COMPANY: ARTCOM LIMITED

TITLE: CLS-45i BASE MAIN

DRAWN: R&D	DATED: 2005-02-21	COMPANY: ARTCOM LIMITED		
		TITLE: ARTCOM RF MODULE(BASE)		
CHECKED:	DATED:	PCB FILE:		
QUALITY CONTROL:	DATED:	L 0 0 J 0 0		
RELEASED:	DATED:	SCALE:	SIZE: A3	REV: 0
		CODE:	DRAWING NO:	SHEET: 1 OF 1

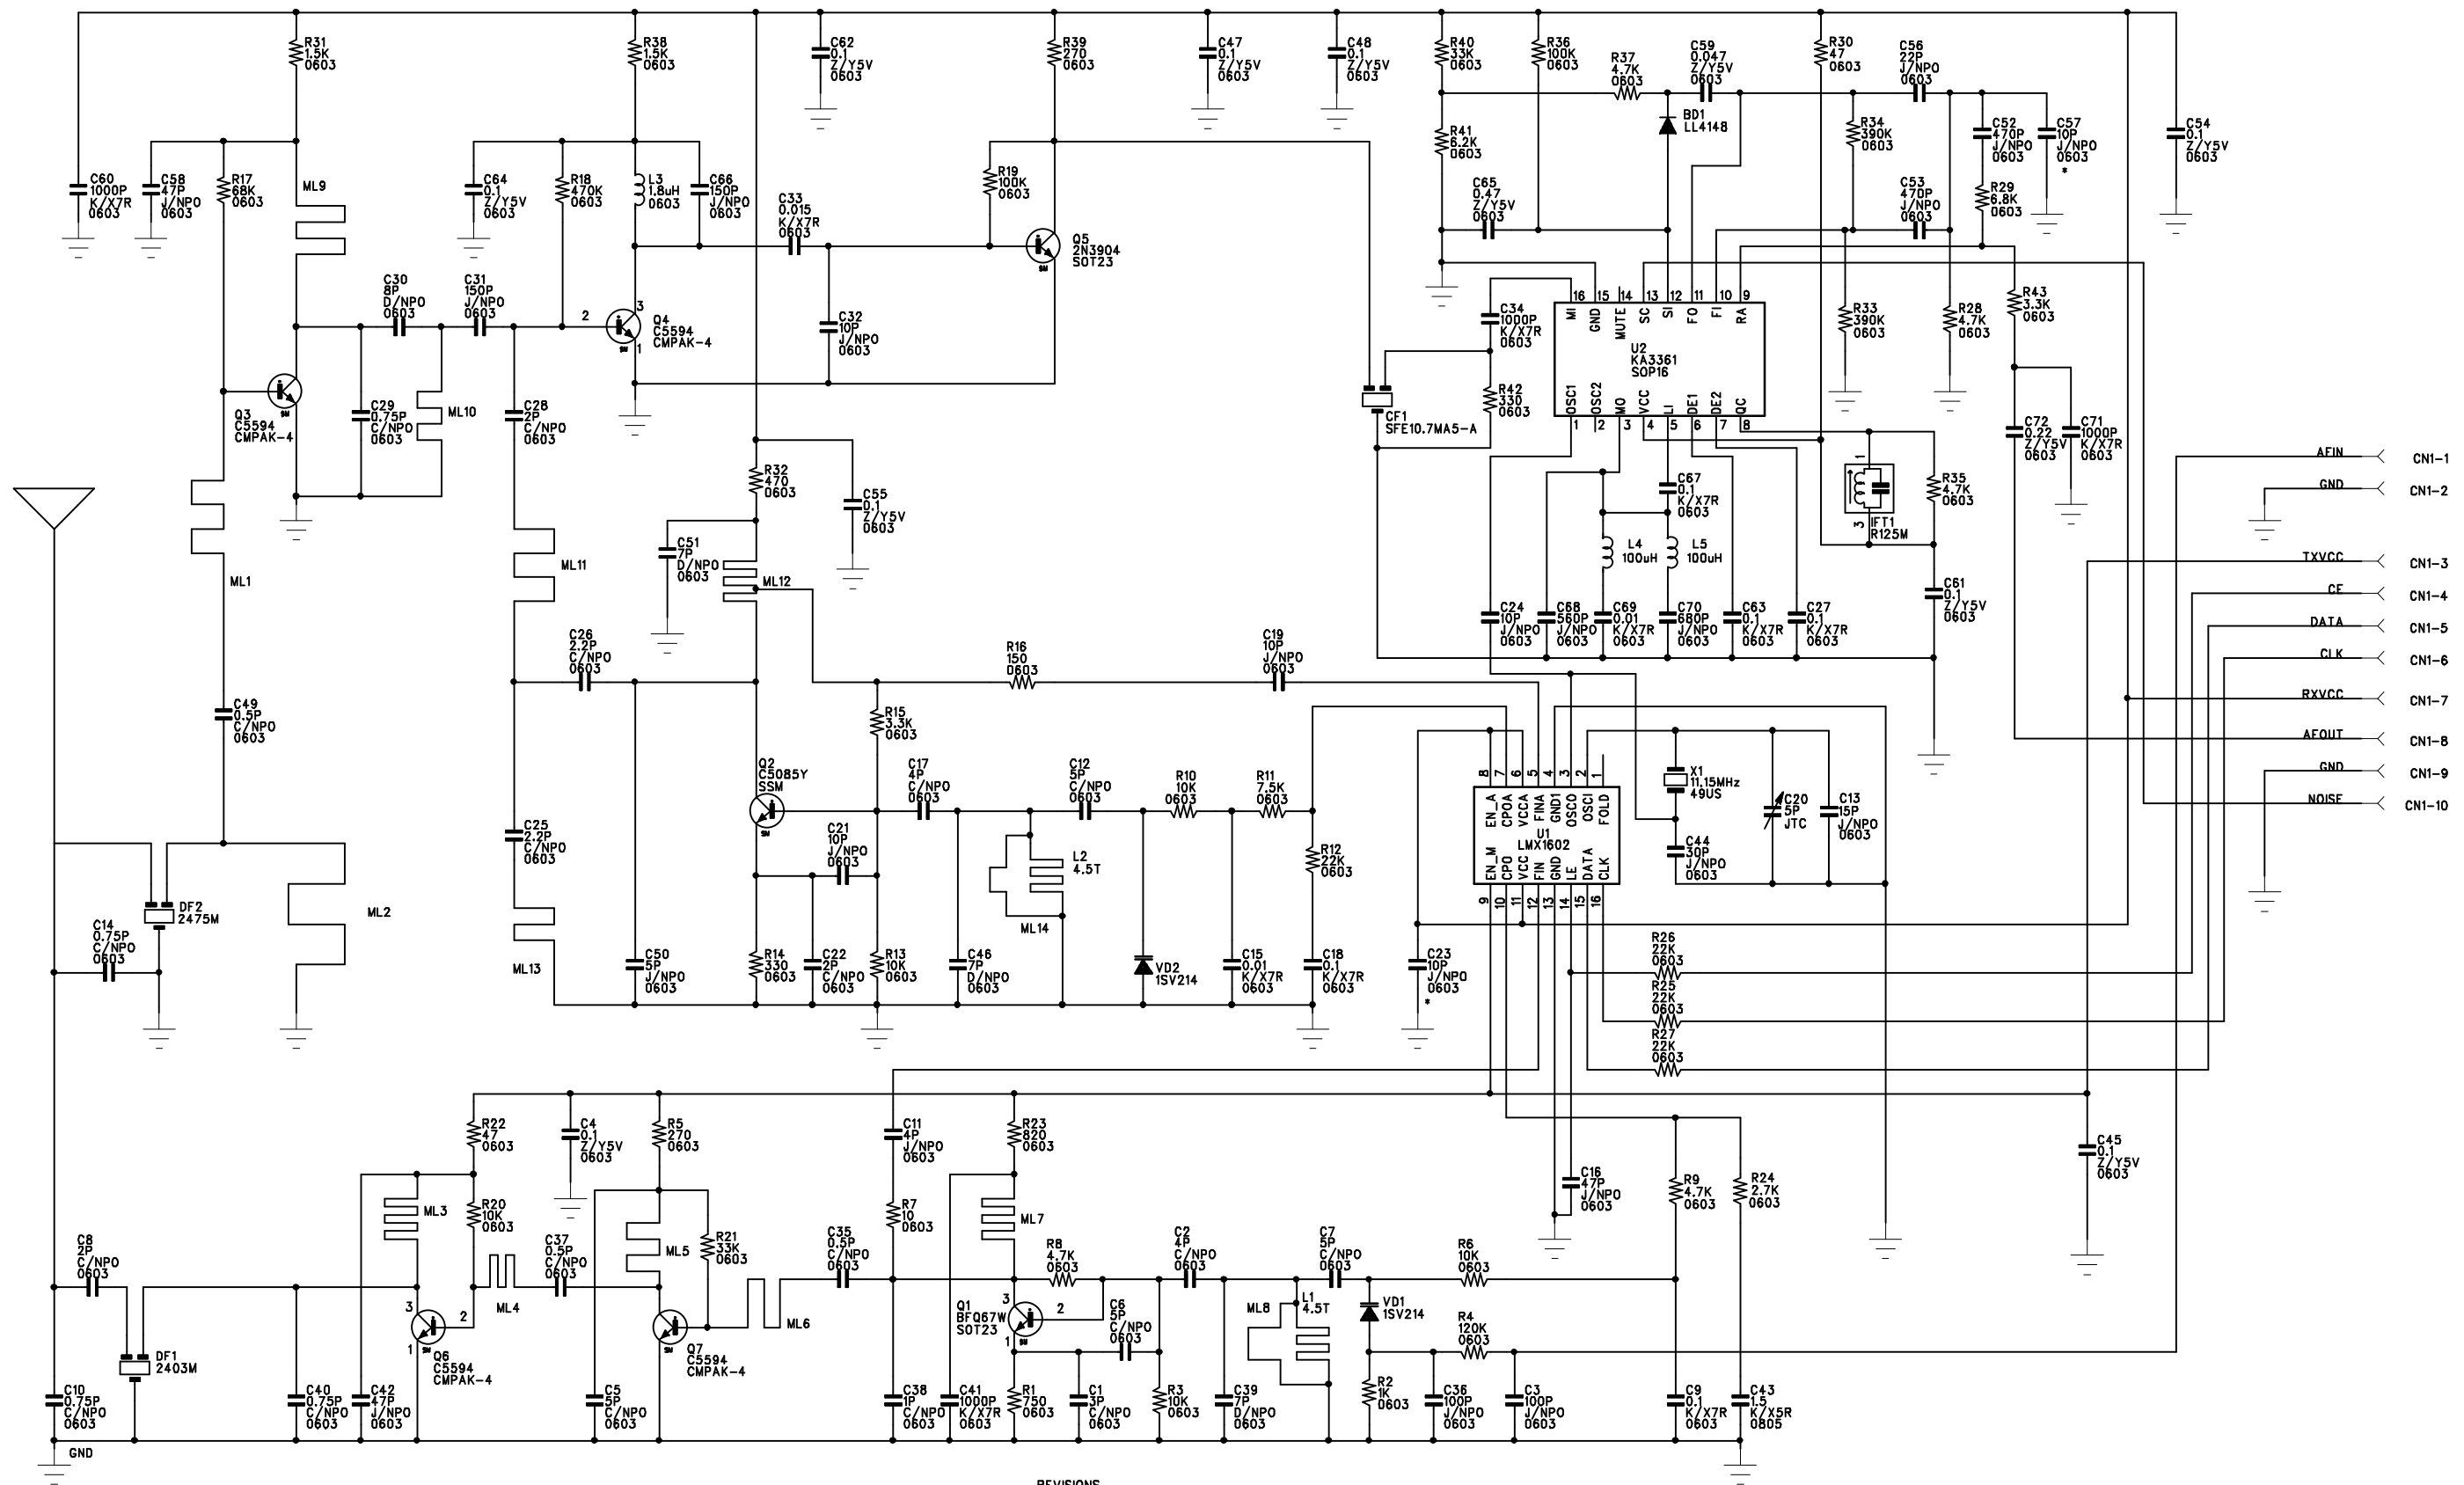
REVISIONS
DATE: 2005-02-21
1. C11 10P CHANGE TO 4P
2. R1 620 CHANGE TO 750.

DRAWN: R&D	DATED: 2005-01-06	COMPANY: ARTCOM LIMITED		
		TITLE: ARTCOM RF MODULE(HANDSET)		
CHECKED:	DATED:	PCB FILE:		
		L O O J O O		
QUALITY CONTROL:	DATED:	SCALE:	SIZE: A3	REV: 0
		CODE:	DRAWING NO:	SHEET: 1 OF 1

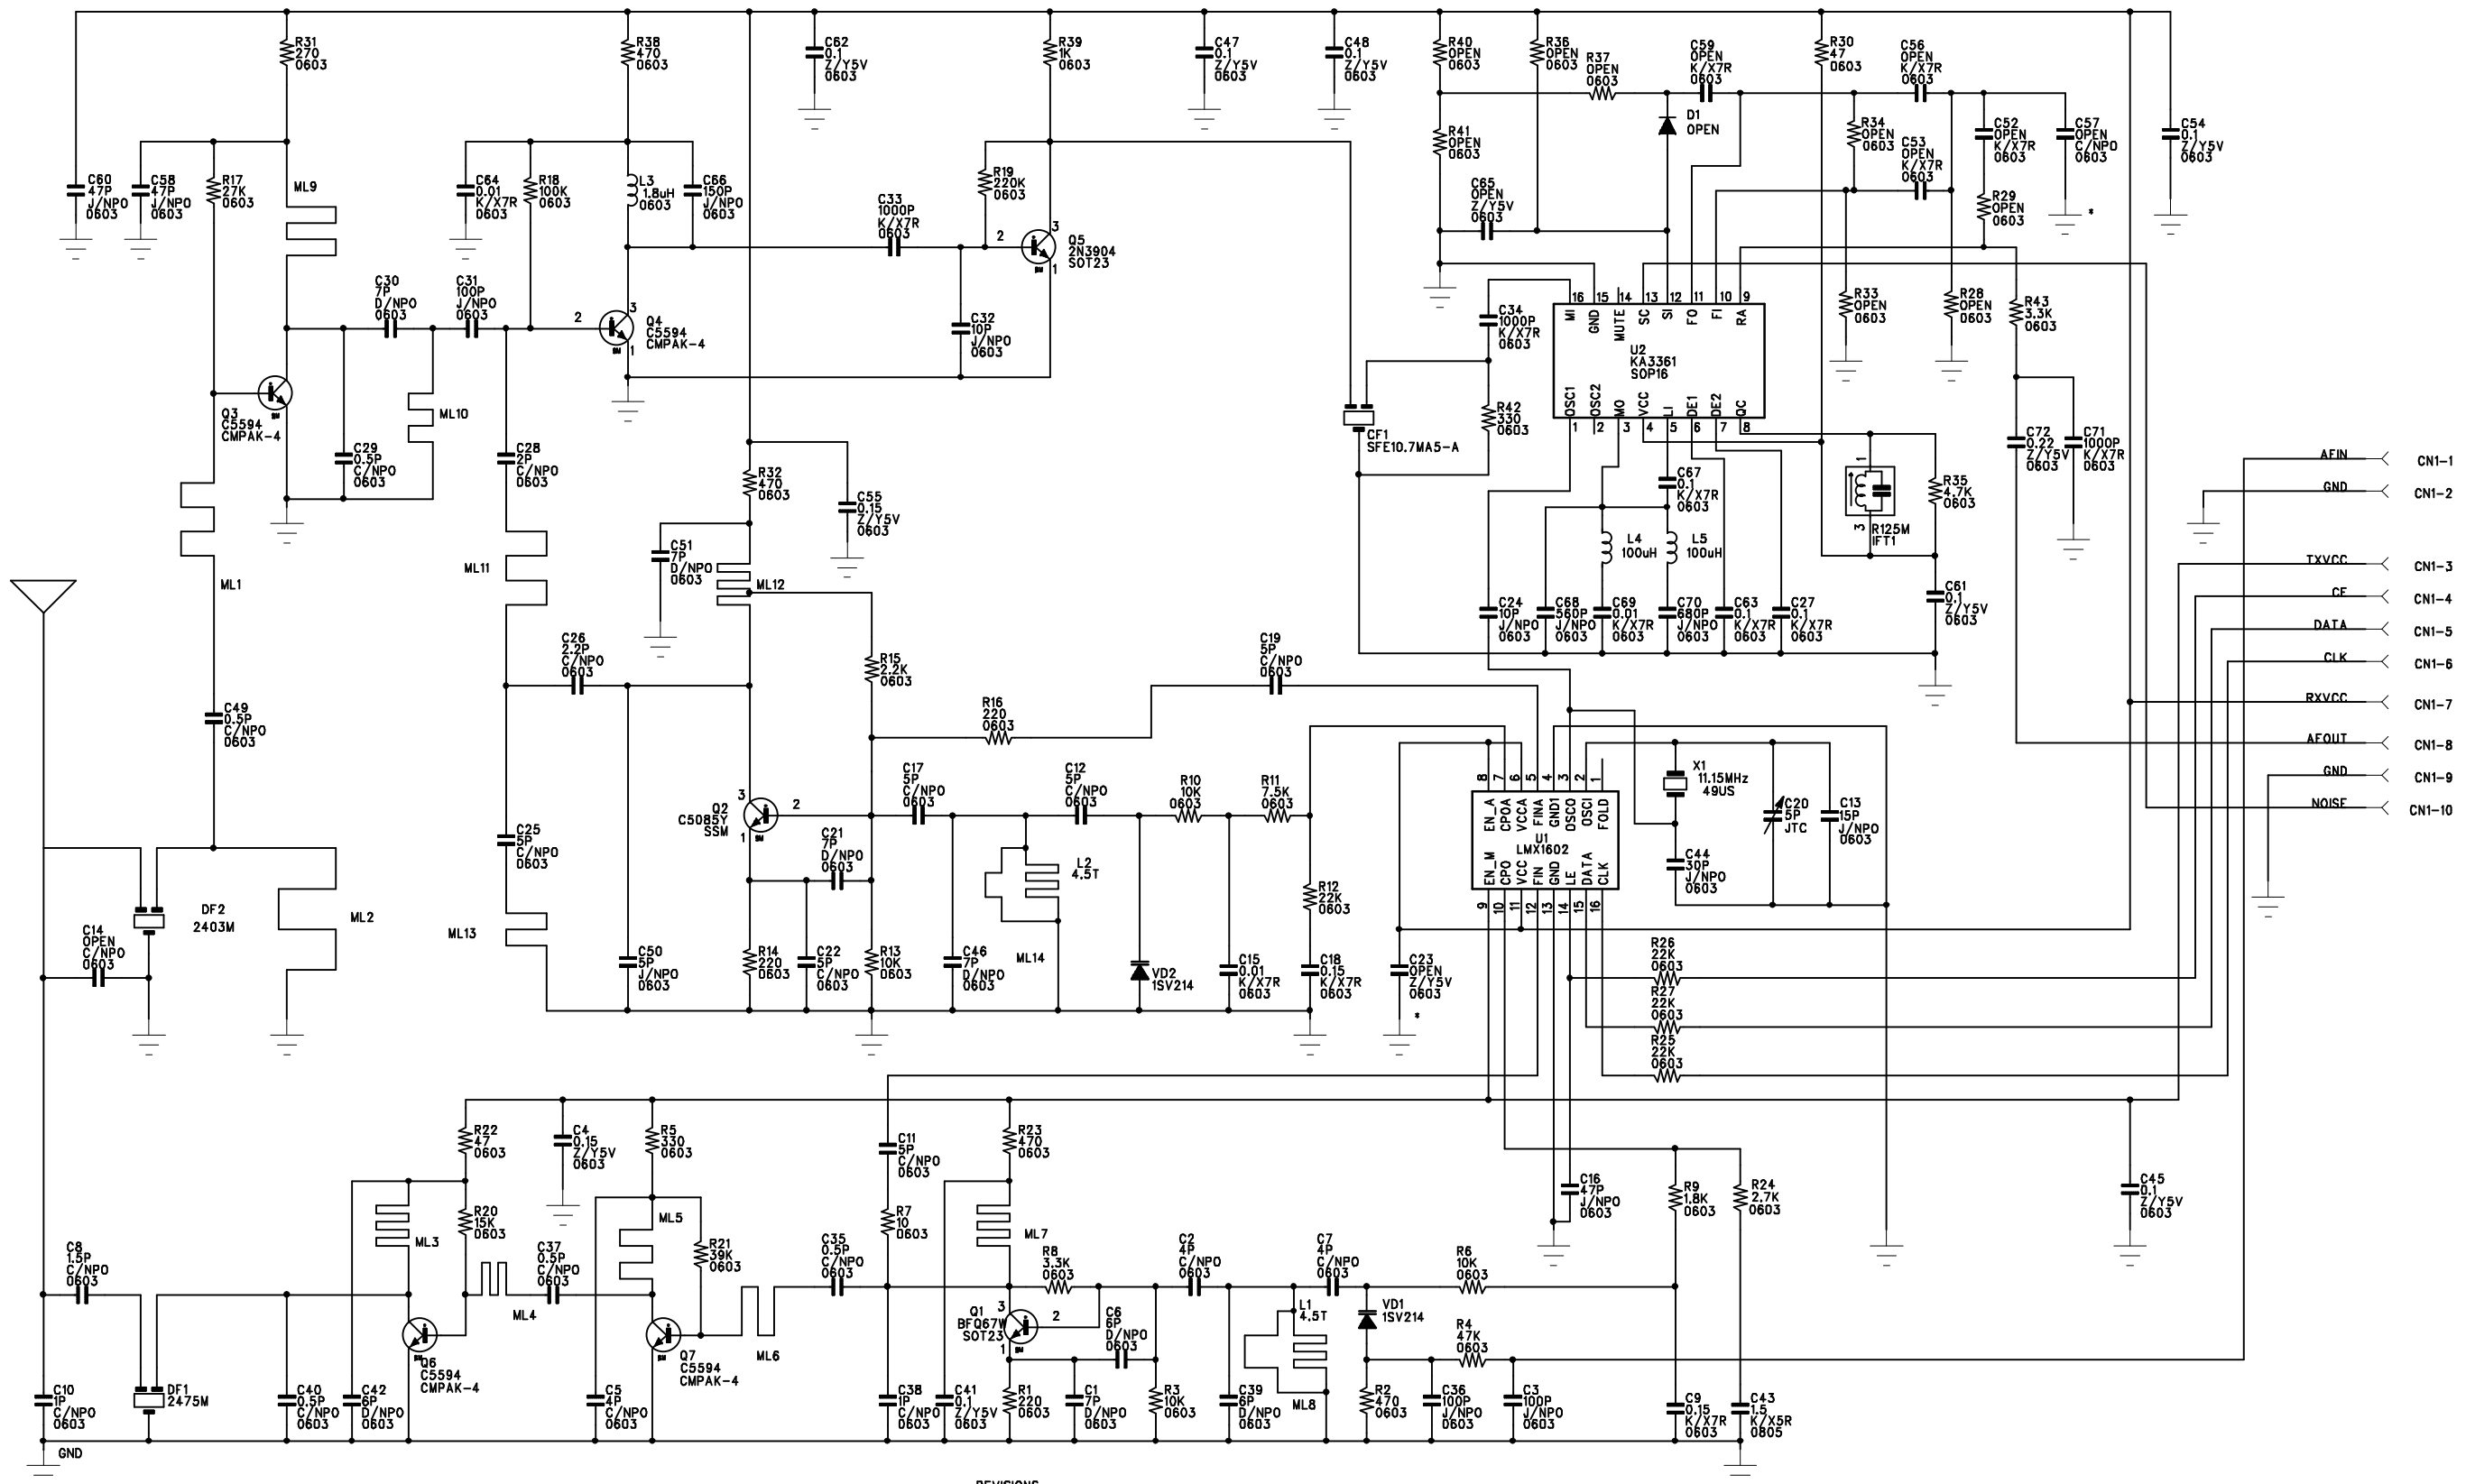
REVISIONS
ECN 02/05/02
1. C12 4P CHANGE TO 5P
2. C44 20P CHANGE TO 24P
ECN 04/13/02
1. VD1 VD2 KDV154C CHANGE TO 1SV214
ECN 04/18/02
1. C51 3P CHANGE TO 7P
